July 25, 2002

**Subject: Terminal 1 South  
Response to Approval Comments on Removal Action Work Plan  
ECSI File No. 2042**

**Proposed Confirmation Sampling  
Terminal 1 South Removal Action  
Port of Portland, Portland, Oregon**

**HARTCROWSER**  
15230-01 7/02  
Figure 7

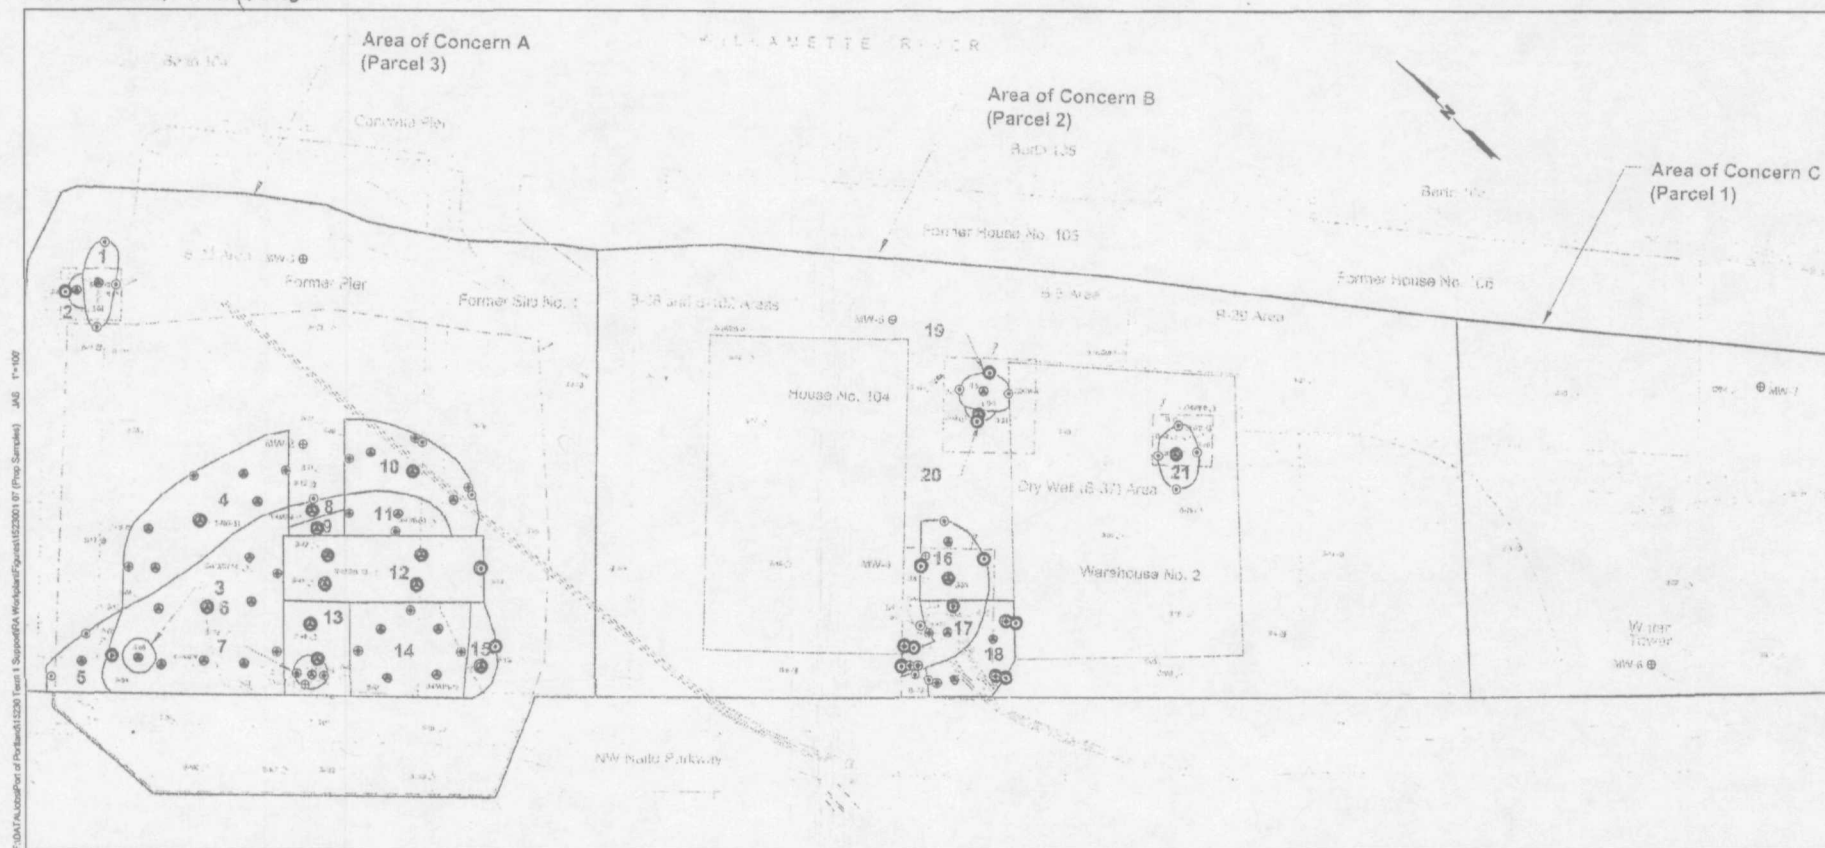
5. Section 5.2/Figure 7/Table 3. Confirmation Samples. DEQ believes additional confirmation samples are needed in the following areas:

- Excavation Area 4. Confirmation samples should be also be collected from 0-3 feet bgs.
- Excavation Area 10. Confirmation samples should be also be collected from 0-3 feet bgs.
- Excavation Area 17/18. Confirmation samples should be also be collected from 0-3 feet and 3-15 feet bgs in the eastern most corner (near Warehouse No. 2) of the excavation.
- Excavation Area 17 (Boring B-92 Hot Spot). Confirmation samples should be also be collected from 0-3 feet and 3-15 feet bgs immediately northeast of the hot spot.

6. Section 5.2/Appendix A. The work plan proposes analyzing only selected confirmation samples for PAHs. Since the preliminary soil cleanup levels for the site are based on PAH concentrations all confirmation samples must be analyzed for PAHs. It has not been demonstrated that Total Petroleum Hydrocarbons (TPH) concentrations can be used as a surrogate analyses.

**Response:** The conceptual approach for preparing the confirmation sampling plan was based on the purpose of the excavation, presence of shoring, and the availability of existing data. There are three primary reasons for excavation for this site: excavate soil with PAHs above cleanup levels; excavate soil with TPH above cleanup levels; and excavate clean soil to access soil with TPH above cleanup levels. In general, confirmation sampling is proposed to address the purpose of the excavation being considered, except that, confirmation sampling is not proposed if it duplicates existing data or the presence of shoring prevents access to the soil. Therefore, in response to the above comment:

- Area 4. Samples were collected from 0-3 feet from borings B-69, B-70, and B-71. These samples were analyzed for TPH and PAHs with results below detection limits. Excavation in Area 4 extends northward beyond these points solely for the purpose of accessing deeper soils above the TPH cleanup level. Therefore, the data from B-69, B-70, and B-71 are the confirmation results for the Area 4 excavation and no further data from 0-3 feet is needed or proposed.

- Area 10. Area 10 is analogous to Area 4. However, upon further review, the existing data to the southeast are limited. Therefore, two samples will be added to the southeast side of Area 10 in the 0-3 foot depth range. The new samples will be analyzed for TPH (see response to comment 6 below). A revised Figure 7 is attached.

- Area 17/18 and Area 17 (Boring B-92 Hot Spot). The confirmation sampling scheme in this area was complicated by the presence of shoring near the buildings. These buildings have been demolished so shoring is no longer required. Therefore, the confirmation sampling plan has been modified by adding samples adjacent to former Warehouse No. 2 and House No. 104 (at both 0-3 and 3-15 foot depth intervals). The samples will be analyzed for TPH and PAHs. See revised Figure 7 attached.
